Submissions by Location – Click on title to be ‘hyperlinked’ to the relevant page

C90 general

PLANNING SCHEME AMENDMENT C90

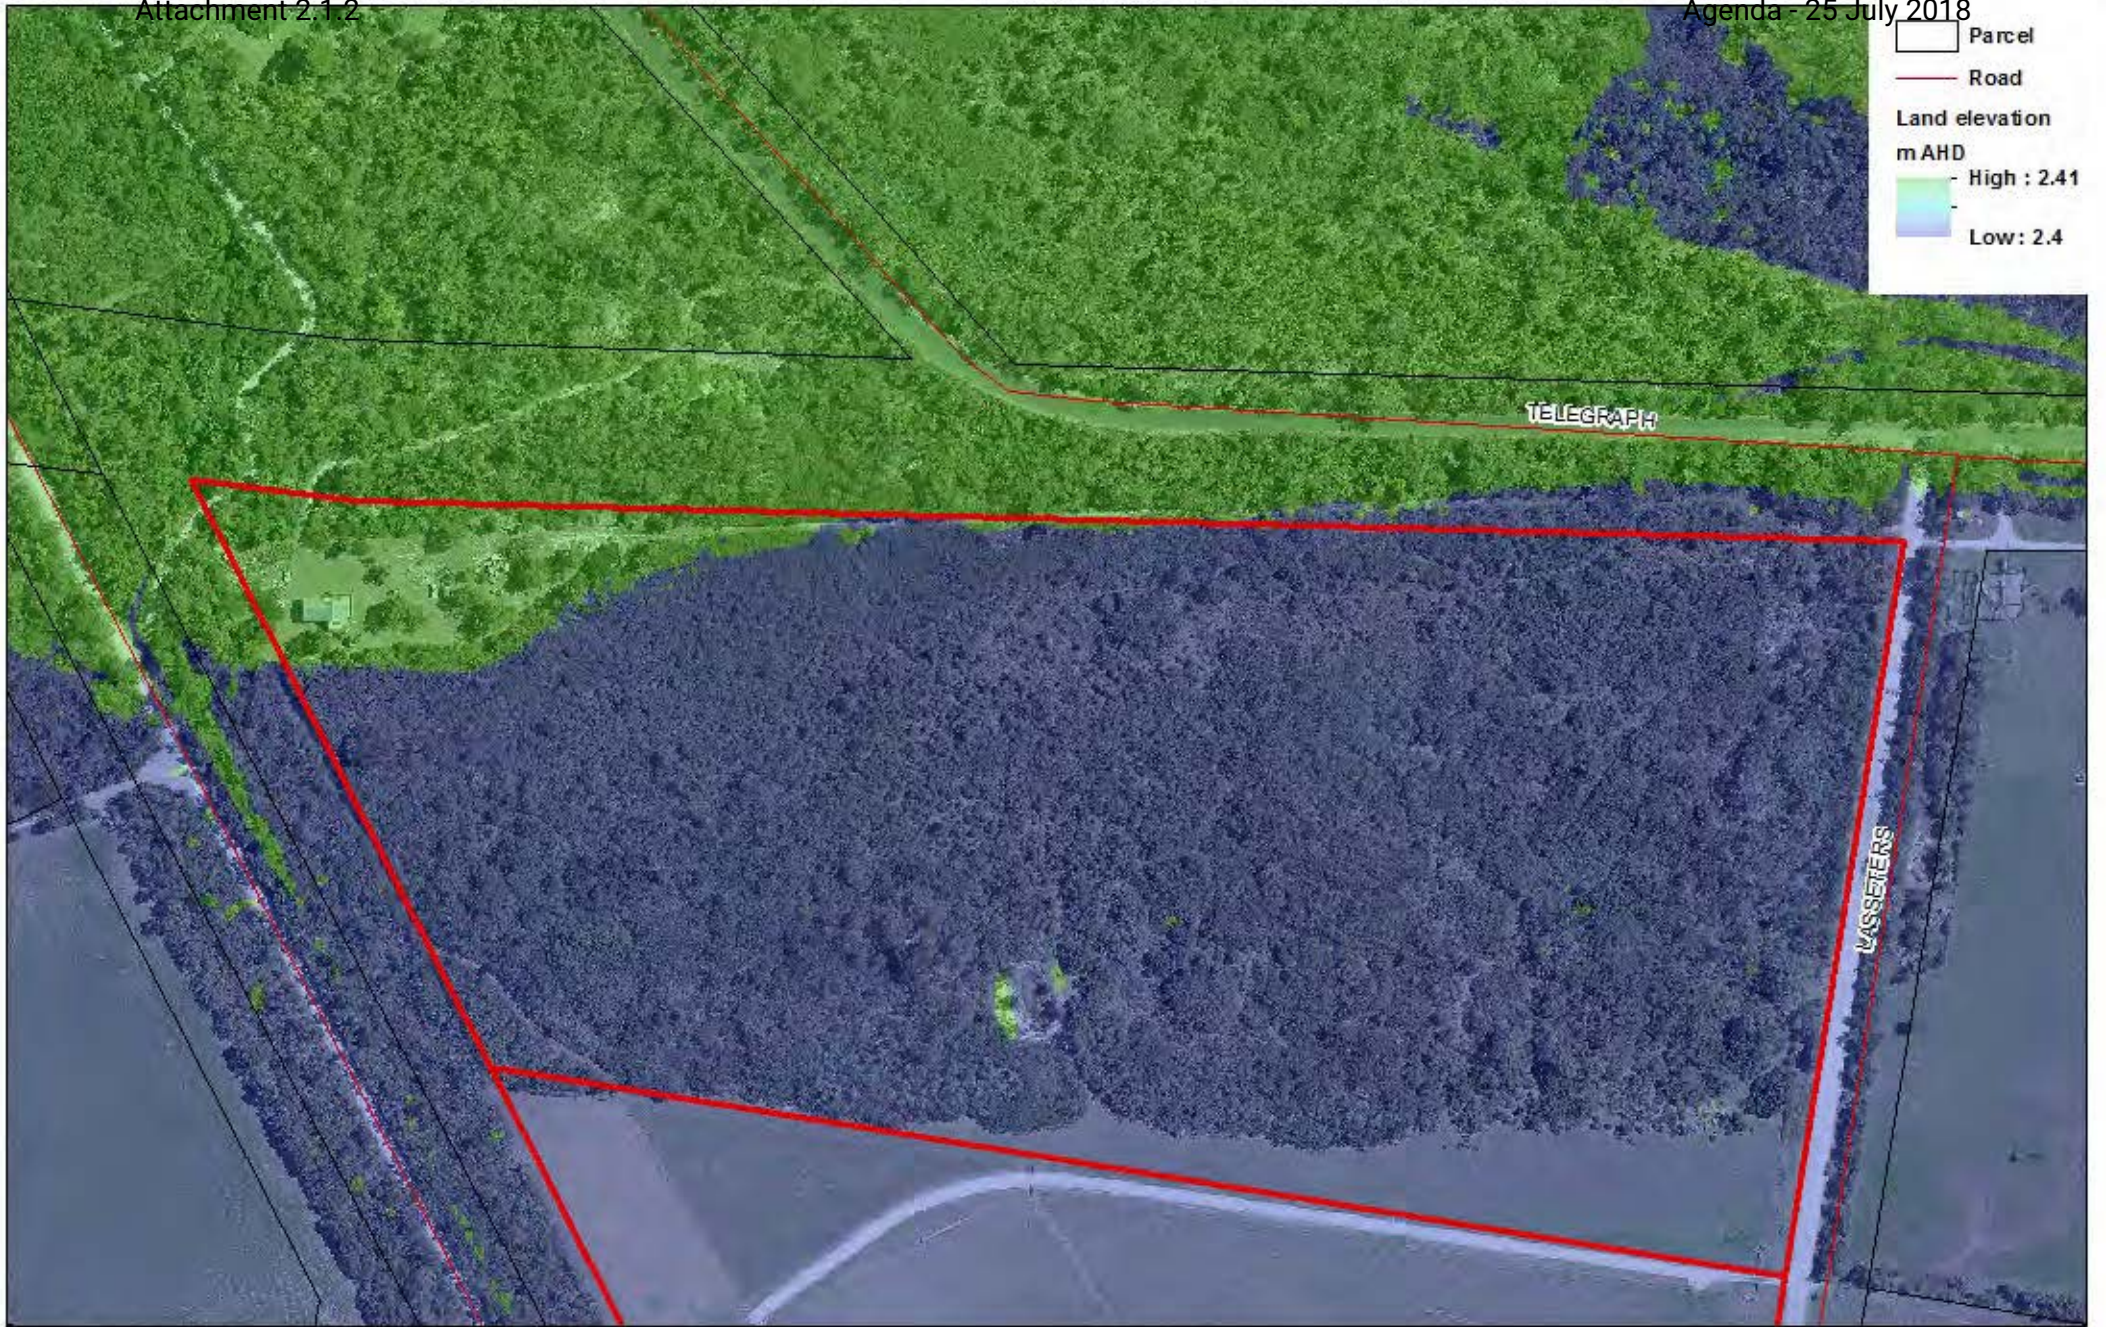
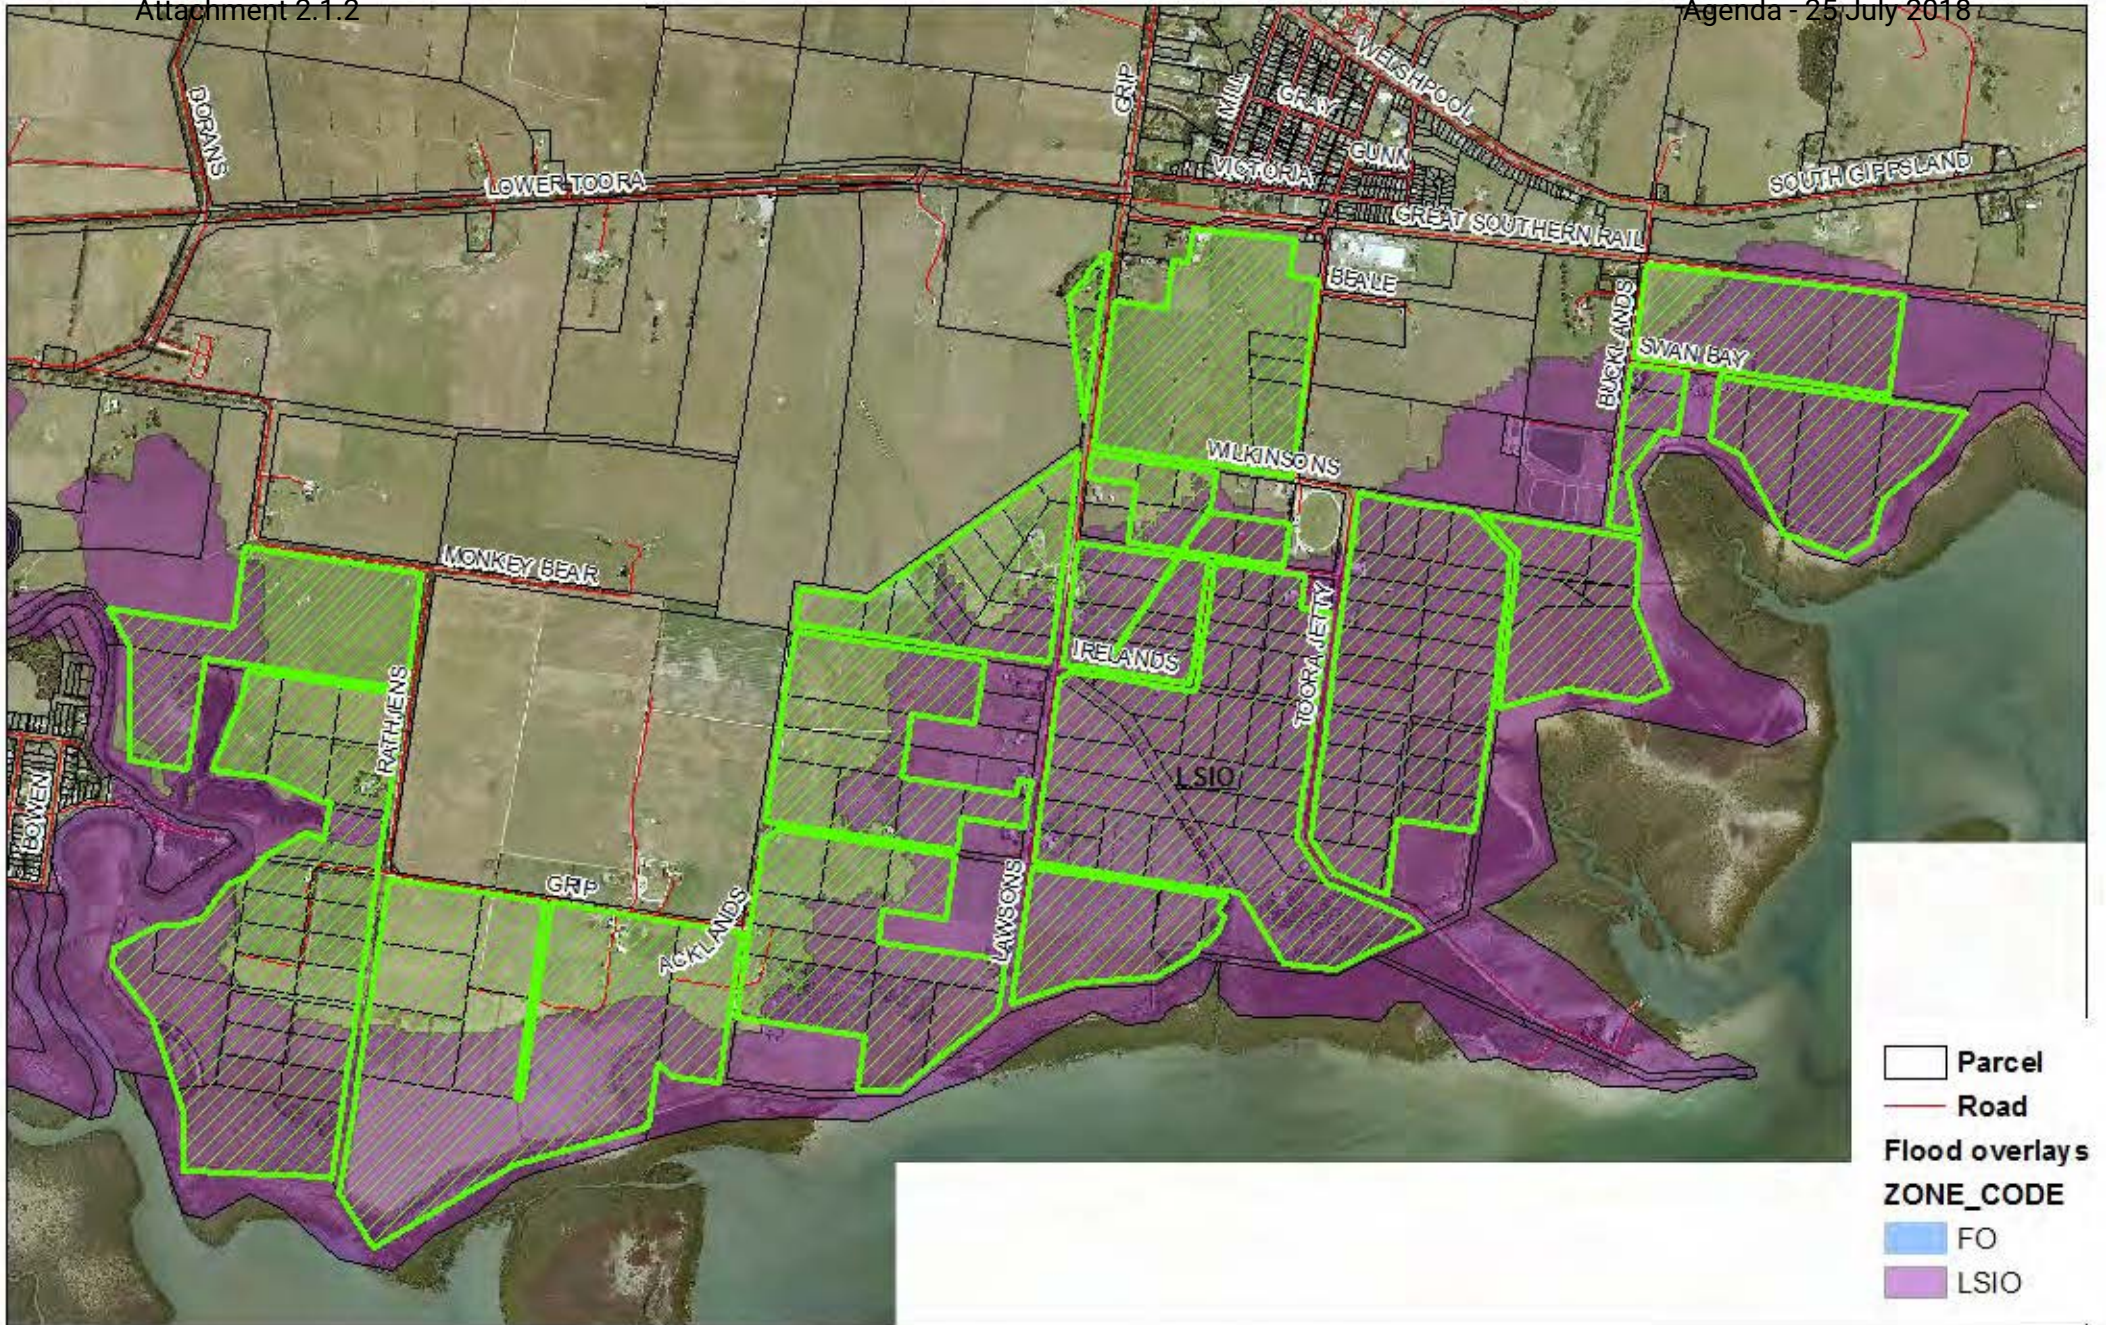
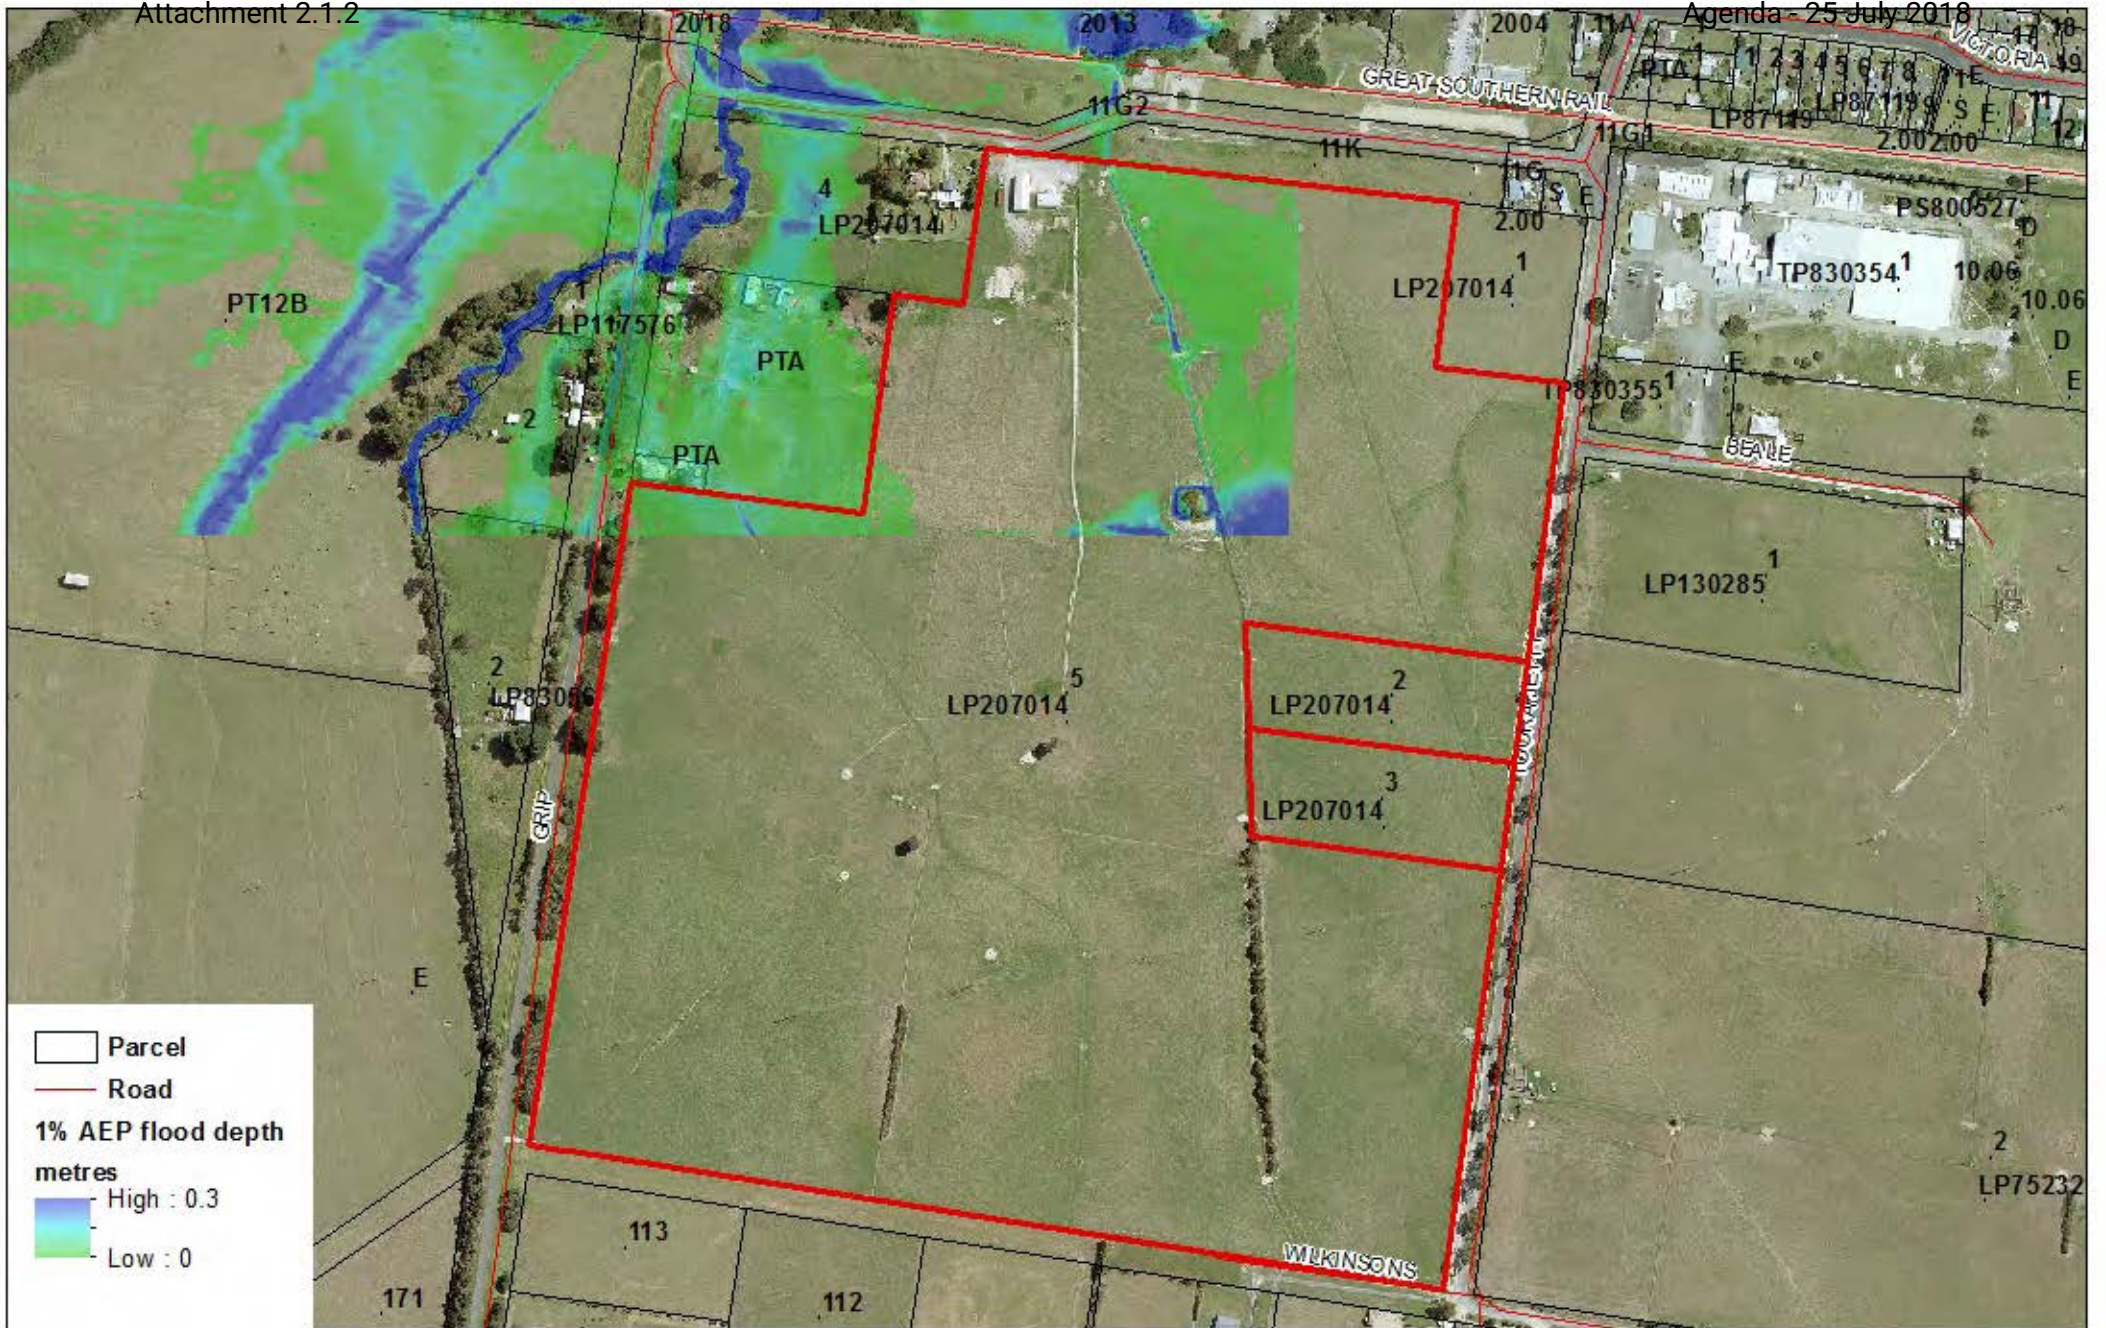
(Note – plans attached have land subject to 0.3m or greater flood depth shaded blue. This is based on LiDAR and not detailed survey).

1. Lot 5 - You are correct and this was an oversight on my part as the LSIO is slightly more extensive over the north east corner of this lot than our estimated 1% AEP flood extent. Based on our estimated 1% AEP flood extent, there is an area of approximately 1800 sqm (which may be refined if detailed survey were undertaken) that meets our criteria as shown in the attached map. The summary table for Port Welshpool has been updated (with changes to Lot 5 only) below.

2. Lot 4 - The area that meets our criteria is shown in the attached plans (at different scales) and corresponds with the LSIO.
3. Lot 16 - The area that meets our criteria is shown in the attached plan and corresponds with the LSIO. On CA 15 and 15A, development would only be supported where both it and its access are subject to < 0.3m flood depth (shaded green) and public access would need to be created for CA 15.

4. For all of the lots other than 23 and 24, as per the summary table for Toora, we'd support dwellings where both the dwelling and access are outside the LSIO. As you have access to the LSIO, I haven't created a plan of each of the lots. However there is no LSIO around Lots 23 and 24 so I have attached plans for each of those lots showing the area that meets our criteria. The flood modelling we've done does not cover the entire lots (which is why there is a sharp boundary to the flood depth layer in the maps) and we'd include the un-modelled land in the area which is appropriate for development. Any land shaded blue doesn't meet our criteria, but anything else – whether shaded green or not modelled - does.
